CHAPTER 3

Responses to Draft EIR Comments

3.1 Introduction

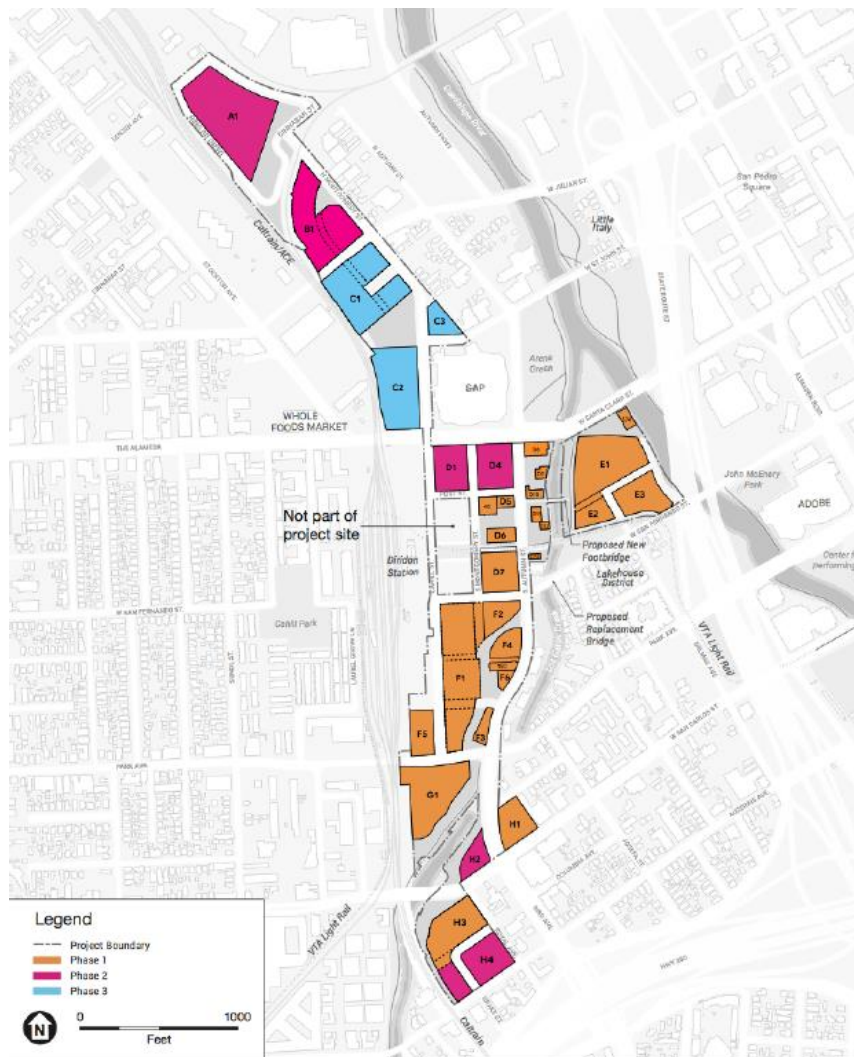
LU-1.9 Preserve existing Public / Quasi-Public lands or include parks and open space improvements in redevelopment projects in order to maintain an inventory of sites suitable for Private Community Gathering Facilities, particularly within the Residential Neighborhoods, Urban Villages and commercial areas, and to reduce the potential conversion of employment lands to non-employment use. **Public / Quasi Public lands located within the Diridon Station Area Plan may be re-designated to other uses provided that such uses will advance San José's employment growth or housing goals and include parks and open spaces within the development.**³

The proposed General Plan amendment cited by the commenter (which has been revised somewhat from the version quoted in the comment; see below) is specifically intended for the site currently occupied by surface parking Lots A, B, and C adjacent to SAP Center, which have a General Plan land use designation of Public / Quasi-Public, as indicated in Draft EIR Figure 2-4, *Existing and Proposed Changes to General Plan Land Use Designations*, page 2-26. The amendment would permit Lots A, B, and C to be redeveloped as mixed-use under the Downtown West project (which otherwise would have only allowed public serving land uses under the Public/Quasi-Public designation).

As also indicated in Figure 2-4 and stated on Draft EIR page 2-25, the San José Fire Department training center is designated Open Space and is not subject to Policy LU-1.9, as this policy is only applicable to land designated Public/Quasi-Public. Like approximately half of the project site, this parcel is proposed to be designated Commercial Downtown. As further explained on Draft EIR page 2-25, in lieu of a community park on the Fire Department training site, the proposed project would provide for approximately 15 acres of parks and open space—in parks and plazas, including areas for outdoor seating and commercial activity (such as retail, cafes, and restaurants), landscaping, mid-block passages, semi-public spaces, riparian setbacks and corridors, and trails—that would be designated throughout the project site in the Planned Development zoning for the project. The 15 acres of open space proposed would exceed the up to 8 acres of open space that would have been provided by a community park on the fire training site.

The text of the proposed General Plan amendment has been amended since publication of the Draft EIR and now reads:

LU-1.9 Preserve existing Public / Quasi-Public lands in order to maintain an inventory of sites suitable for Private Community Gathering Facilities, particularly within the Residential Neighborhoods, Urban Villages and commercial areas, and to reduce the potential conversion of employment lands to non-employment uses. **Lands designated Public / Quasi-Public located within the Diridon Station Area Plan may be re-designated to other land use designations provided that such uses will advance San José's employment growth or housing goals and any redevelopment projects include publicly accessible open space and other community amenities.**

Applicant's Proposed distribution of unbuilt space.

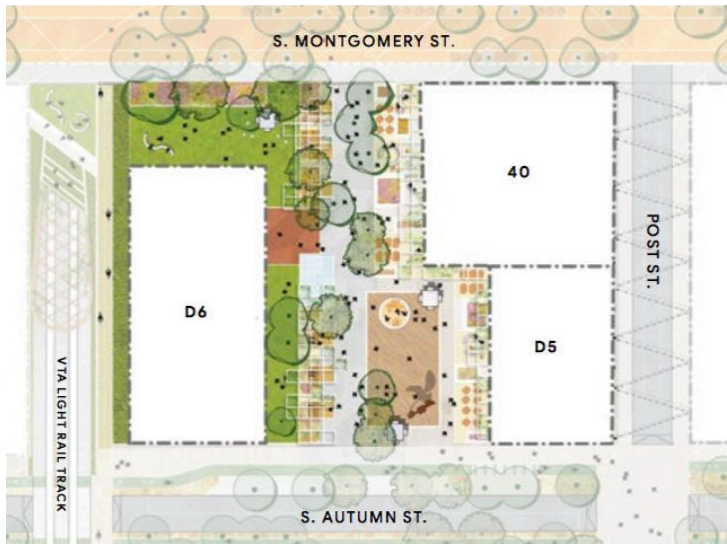
The **privately owned publically accessible parks** “*may have more limited hours of public access than City-dedicated parks*”¹¹ Nowhere is there a published statement of access. Will the public be allowed one day per week? One day per month? One day per year—like Gramercy Park in New York City? Will this property be closed for Google events, such as conventions or sales trainings or retreats? Who decides when it is open or closed? Who decides when it is *too limited*? How does limited access promote equity, a key principle of both San José’s General Plan Park policies and *Activate SJ*?

As an example of a specific concern, the “Los Gatos Creek Multi-Use Trail” (0.28 acres) is within the Google-owned “Los Gatos Creek Park” which is comprised of 2.21 acres and is subject to Google’s closure and limited hours. How will the City’s Multi-Use trail stay open if Google controls the operating hours of all of the surrounding land? Will trail users be expected to detour? What reduction in park credit will be made as a result of limitation?

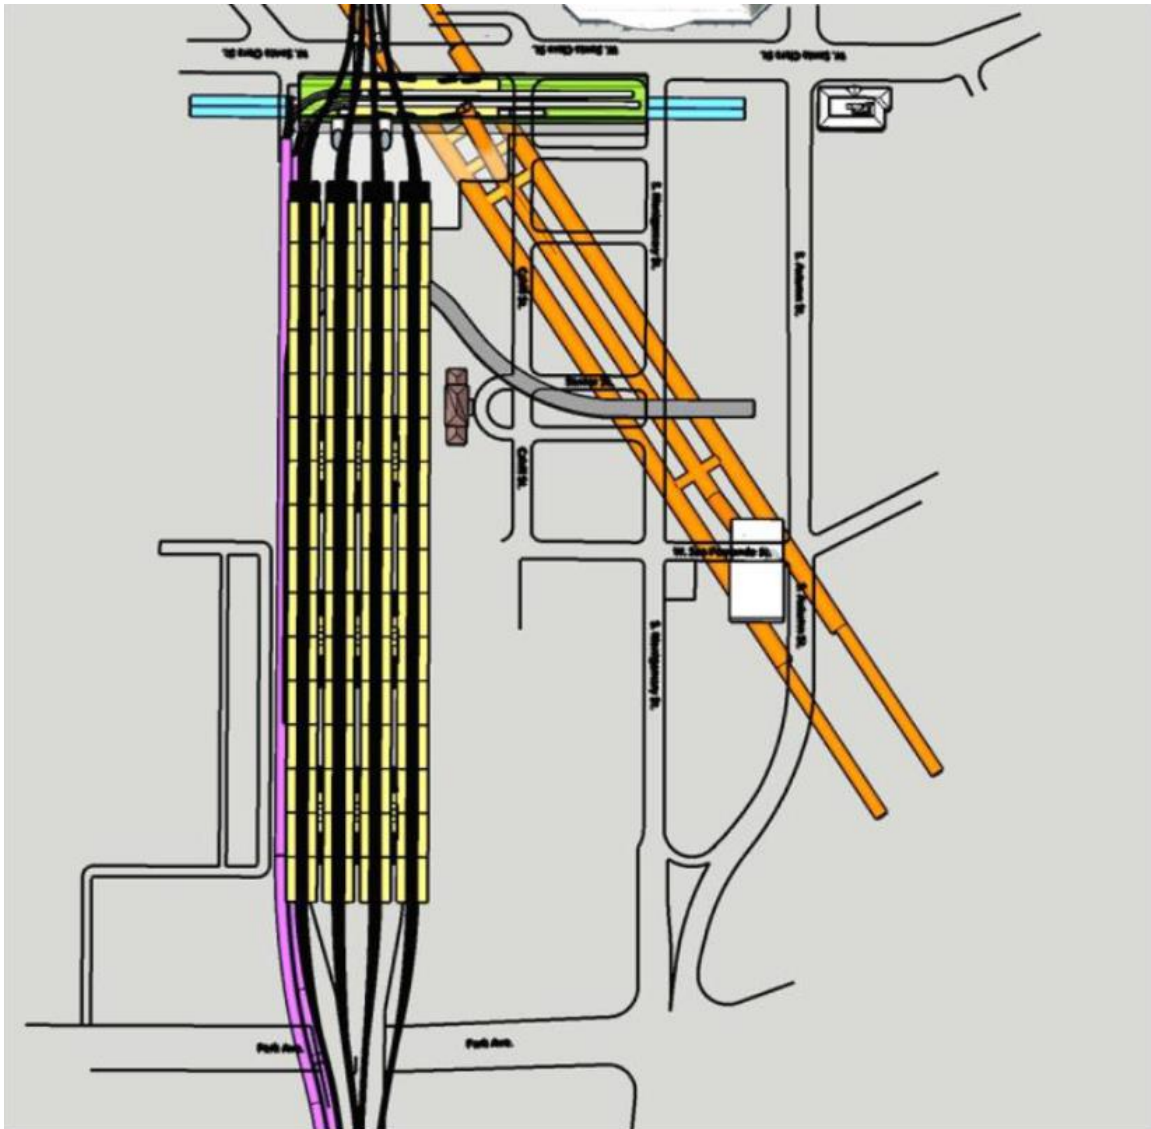
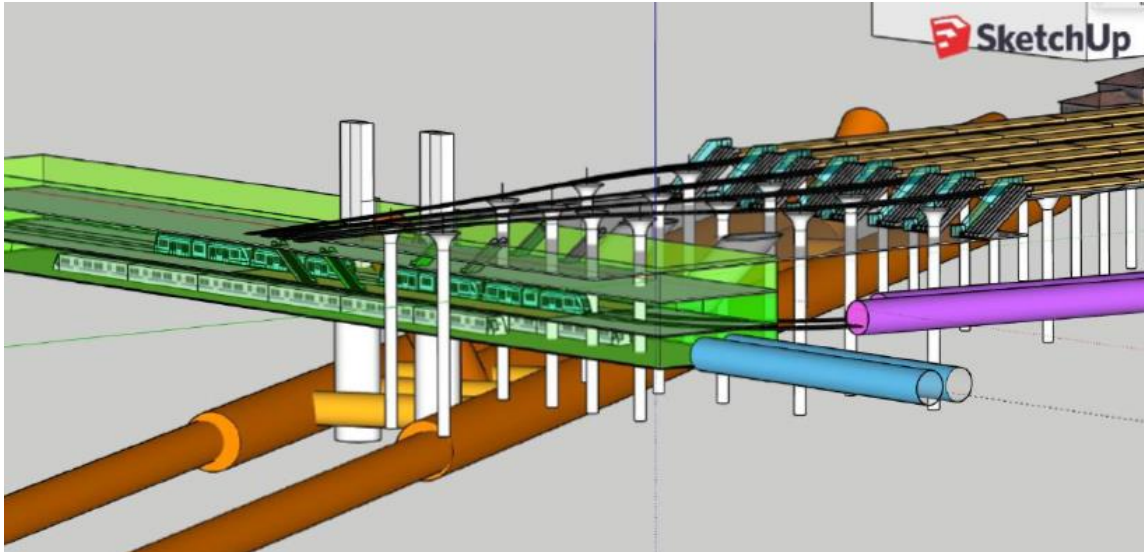
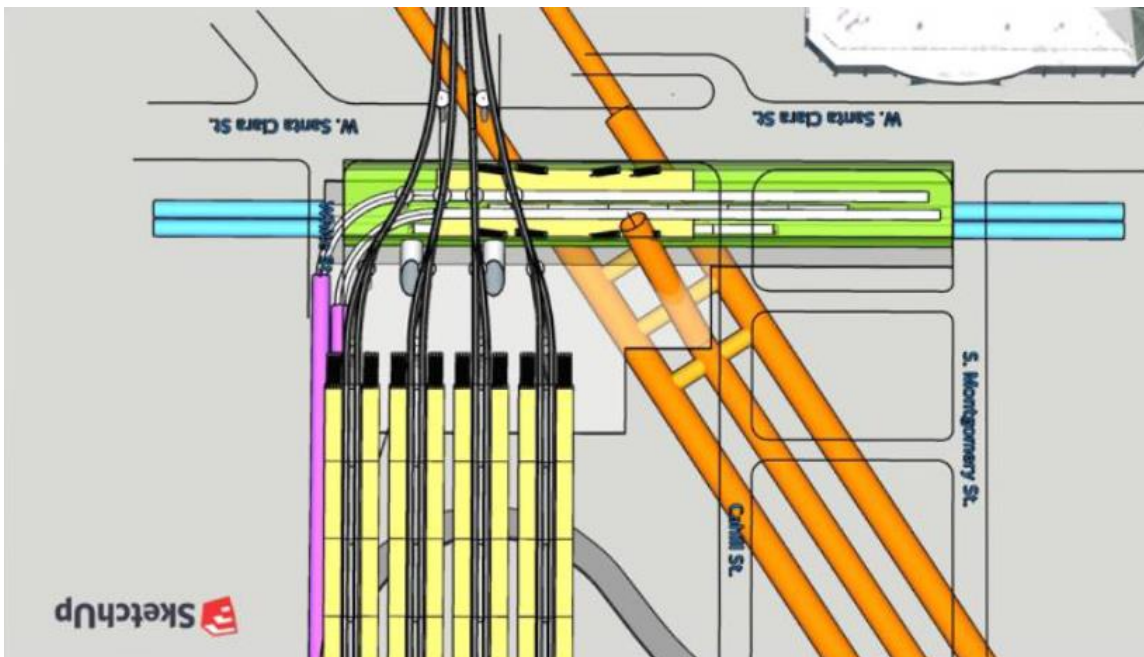
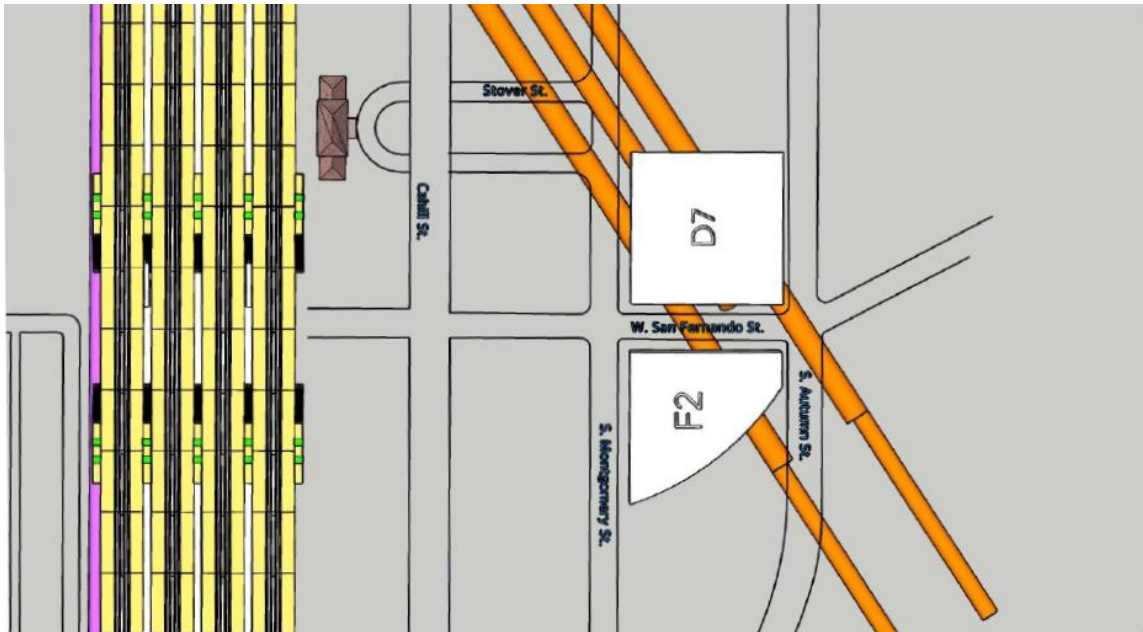
The proposed elevated station will have 6 main entrances (3 on each side):

- Santa Clara (public transportation)
- Paseo de San Fernando (active transportation)
- Park (private transportation)

Construction phasing will start with the relocation of the light rail tracks to a tunnel (purple) between Sunol and White Street to the light rail (yellow) platforms located between the concourse and the BART (green) platforms (this configuration is similar to the MUNI Embarcadero station).

Next, the two west-most heavy rail tracks and platforms will be raised above the area currently occupied by the light rail station and tracks.

Please note that the extended heavy rail platforms will be centered between Park and West Santa Clara to eliminate conflicts with Parcels A, B & C. Additionally, the number of elevated station tracks will be reduced from 10 (or 11 as currently proposed) to 8 to eliminate throat expansion(s) beyond the existing right of way.

The 9th and 10th tracks will be located underground, one on each side of the future Airport connector concourse (orange). This concourse will connect to the West Santa Clara BART/LRT concourse (above) and a southern entrance at the West San Fernando/Autumn intersection (within building F2 and/or D7).
